**To:** Planning Committee  
**From:** Joe Erceg  
Manager, Development Applications  
**Re:** **APPLICATION BY GRANDSPAN DEVELOPMENT LTD. FOR REZONING AT 4791 STEVESTON HWY. FROM SINGLE-FAMILY HOUSING DISTRICT, SUBDIVISION AREA E (R1/E) TO COMPREHENSIVE DEVELOPMENT DISTRICT (CD/135)**

*To Planning - July 3/02*  
**Date:** June 19, 2002  
**File:** RZ 01-198910  
8060-20-7391 xref: 8060-20-7392

| <b>Attachment 2</b> | Conceptual Site Plan                   |

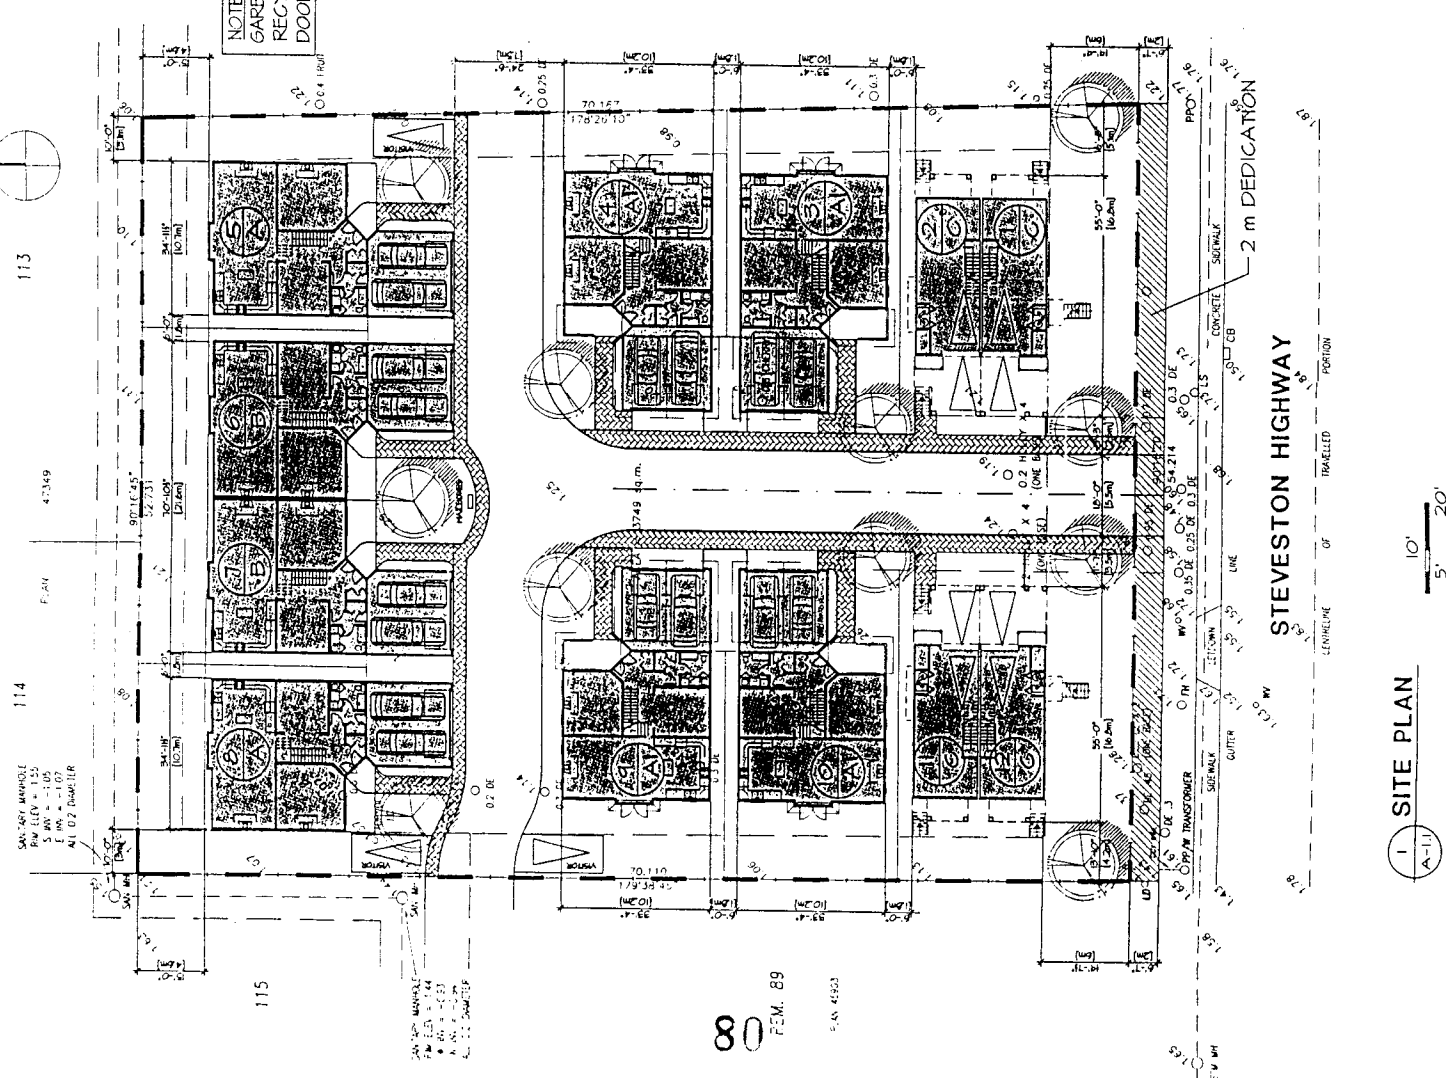
The comments below are based upon the applicant's site plan dated May 24/02 showing 12 units on strata title, 8 units single family character and 2 duplexes (4 units). These design related comments can be addressed through the Development Permit application/servicing agreement stage or earlier. The applicant should:

- Show turnaround capability for all three of the visitor parking stalls (e.g. hammerheads);
- Remove bulge around the mailbox area that encroaches into the laneway;
- Ensure only one vehicular access to Steveston Hwy.;

- Design and provide a “driveway” crossing at Steveston Hwy.;
- Note that for travel lanes, 5.5 m acceptable, however additional width may be required for other purposes (e.g. utilities, lighting, etc);
- Provide a 2 m road dedication required along Steveston Highway;
- Provide a sidewalk that is separated from the travel lanes.
